Project	<b>IEEE 802.16 Broadband Wireless Access Working Group &lt;<a href="http://ieee802.org/16">http://ieee802.org/16</a>&gt;</b>
Title	<b>Proposed text and ASN.1 code to support PKMV1 and PKMV2</b>
Date Submitted	<b>2007-01-11</b>
Source(s)	Joey Chou Intel Corporation <a href="mailto:joey.chou@intel.com">[mailto:joey.chou@intel.com]</a>

Abstract	This contribution proposes the text and ASN.1 code in wmanIf2Mib to support PKMV1 and PKMV2.
Purpose	Adoption
Notice	This document has been prepared to assist IEEE 802.16. It is offered as a basis for discussion and is not binding on the contributing individual(s) or organization(s). The material in this document is subject to change in form and content after further study. The contributor(s) reserve(s) the right to add, amend or withdraw material contained herein.
Release	The contributor grants a free, irrevocable license to the IEEE to incorporate material contained in this contribution, and any modifications thereof, in the creation of an IEEE Standards publication; to copyright in the IEEE's name any IEEE Standards publication even though it may include portions of this contribution; and at the IEEE's sole discretion to permit othe

**Figure 8— wmanIf2BsPkmObjects structure**

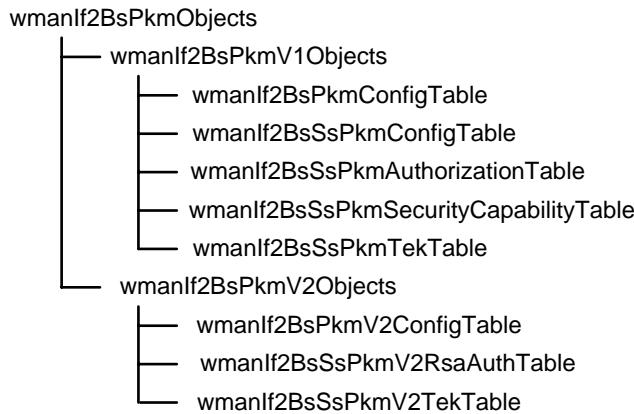
7 [Change Subclause 13.1.3.1.3 as the following:]

10 Figure 8 shows the structure of wmanIf2BsPkmsObjects subtree that contains BS managed objects  
11 related to the MAC privacy management entity.

**Figure 12— wmanIf2SsPkmObjects structure**

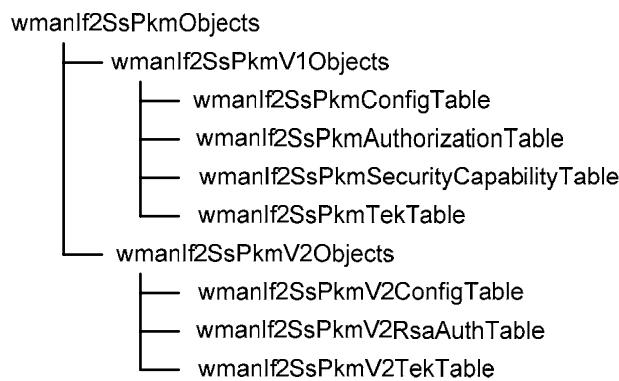
3 [Change Subclause 13.1.3.2.2 as the following:]

6 Figure 12 shows the structure of wmanIf2SsPkmObjects subtree that contains subscriber station  
7 manageable objects related to the privacy management entity.
